Agenda
City of Springboro Planning Commission Meeting
Wednesday, January 18, 2023, 6:00 p.m.
Council Chambers, City Building, 320 West Central Avenue

Background Information Staff Comments/Recommendation
City of Springboro Planning Commission Meeting
Wednesday, January 18, 2023, 6:00 p.m.
Council Chambers, City Building, 320 West Central Avenue

Record Plan, The Ascent, Section 3, western terminus Pinnacle Point Drive, commercial plat

General Plan, Clearview Crossing at Stoneridge, southwest corner of East Central Avenue (SR 73) and Red Lion-Five Points Road, residential subdivision

SHEET NO.: C-400

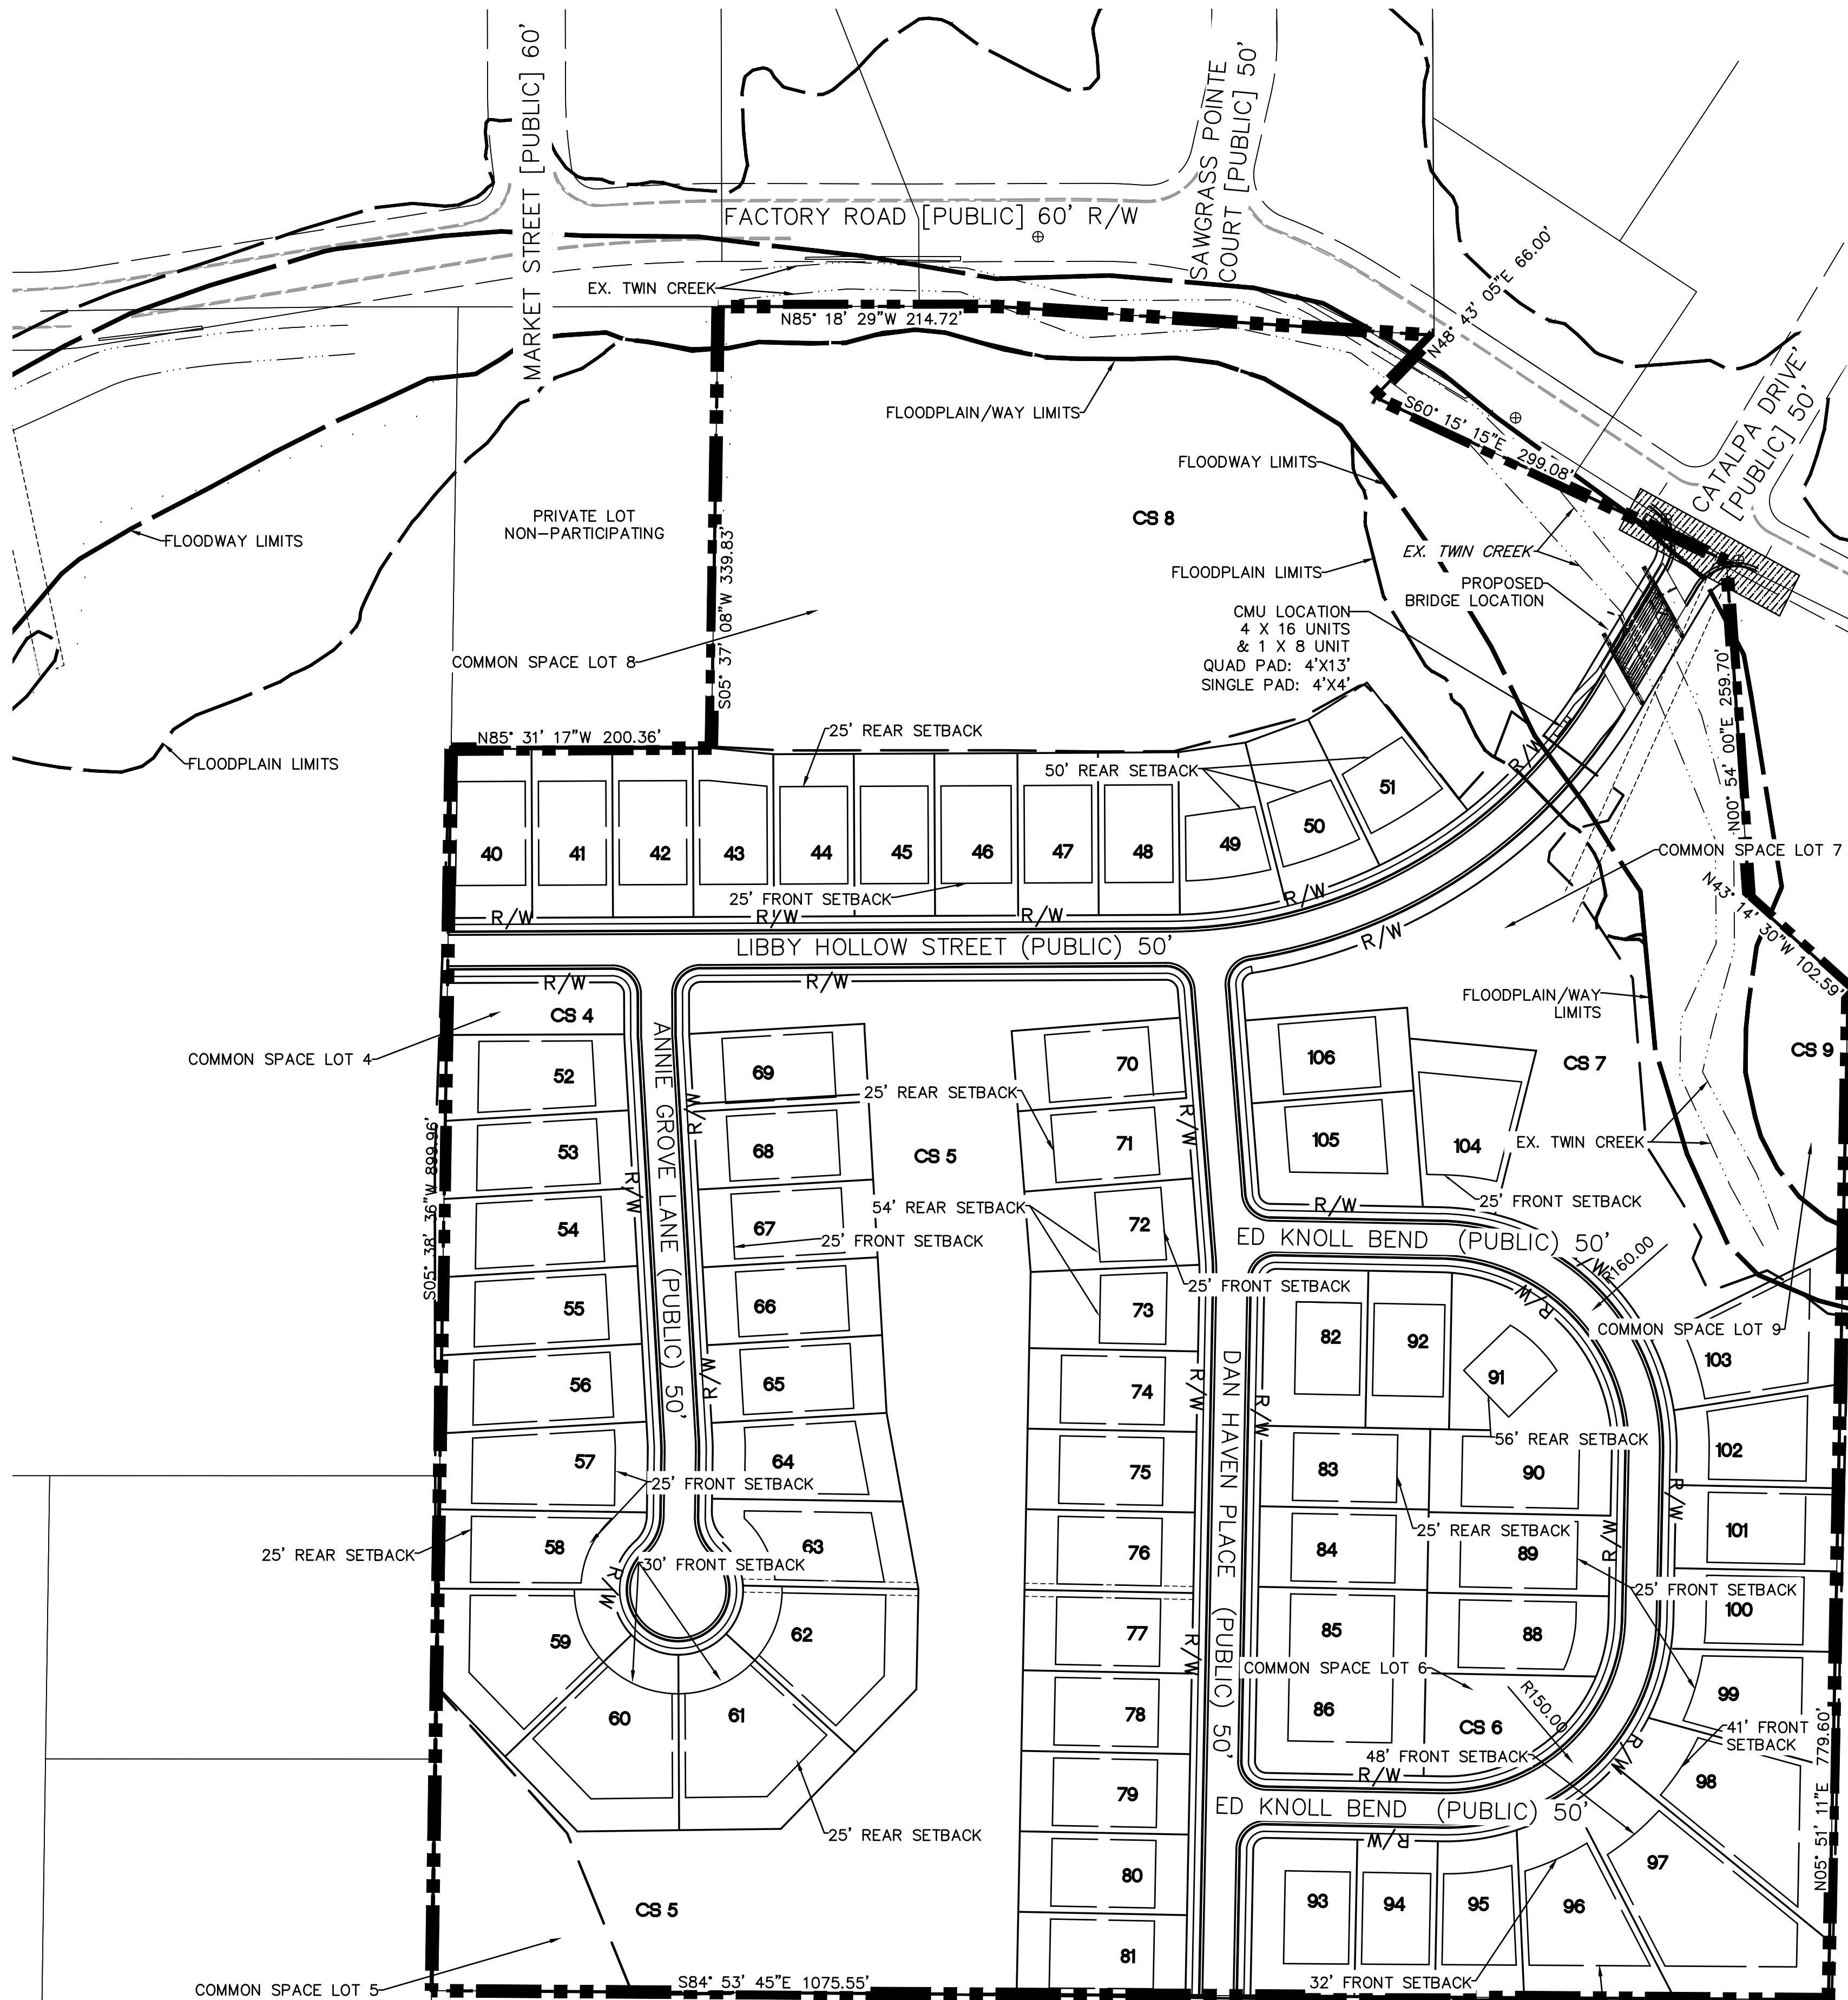
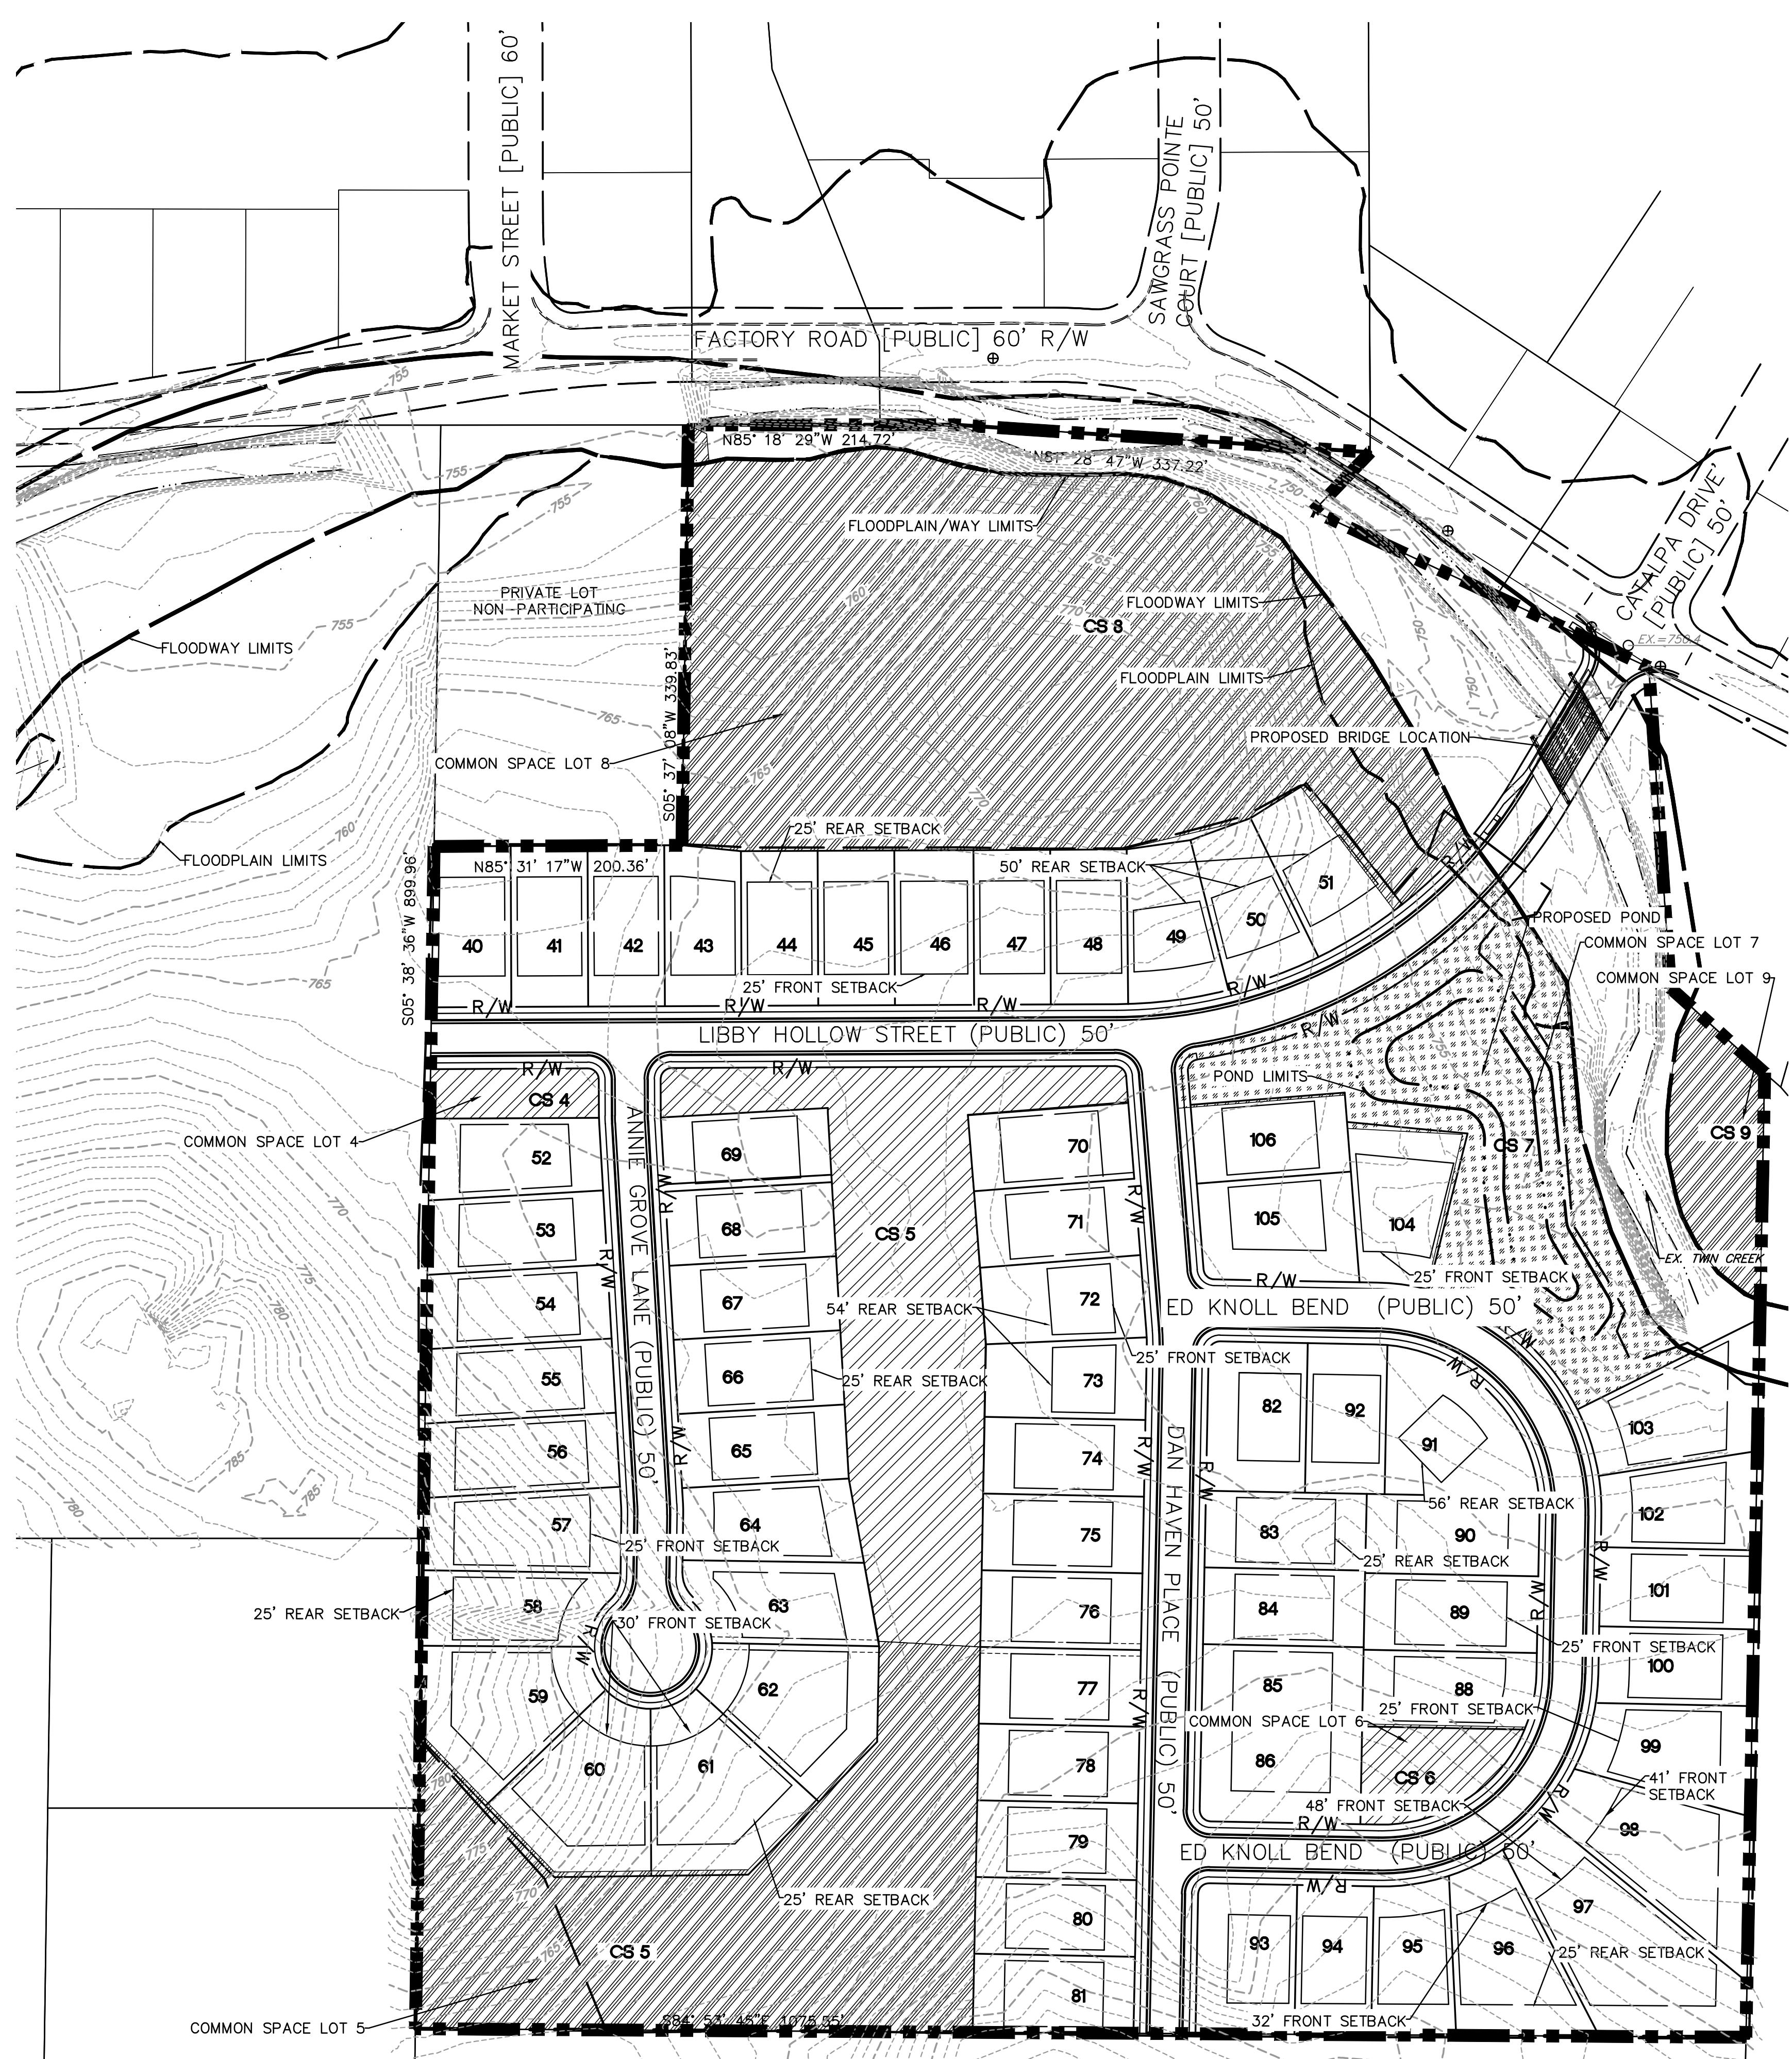
6. A 3" tee and plug (not 2" as noted on plans) shall be stubbed to each property for sump drains to tie into main line sump. Revise note accordingly.
7. Remove buildable home area footprint for lots 9 and 15 to be outside of the Floodway. Development is not permitted in the Floodway. Adjust the setbacks accordingly.

6. Lighting planned for individual home sites to be provided at final development plan stage of development.
7. A 3" tee and plug (not 2" as noted on plans) shall be stubbed to each property for sump drains to tie into main line sump. Revise note accordingly.

8. Homes that cannot be gravity drained by sewer shall not be permitted to have basements. Hung sewers and grinder pumps are not permitted. Remove buildable home area footprint for lot 103 to be outside of the Floodway. Development is not permitted in the Floodway. Adjust the setbacks accordingly. Adjust lot lines for lots 70 to 73 to make the rear yards for lot 72 & 73 standard 25 foot rear setback lots.
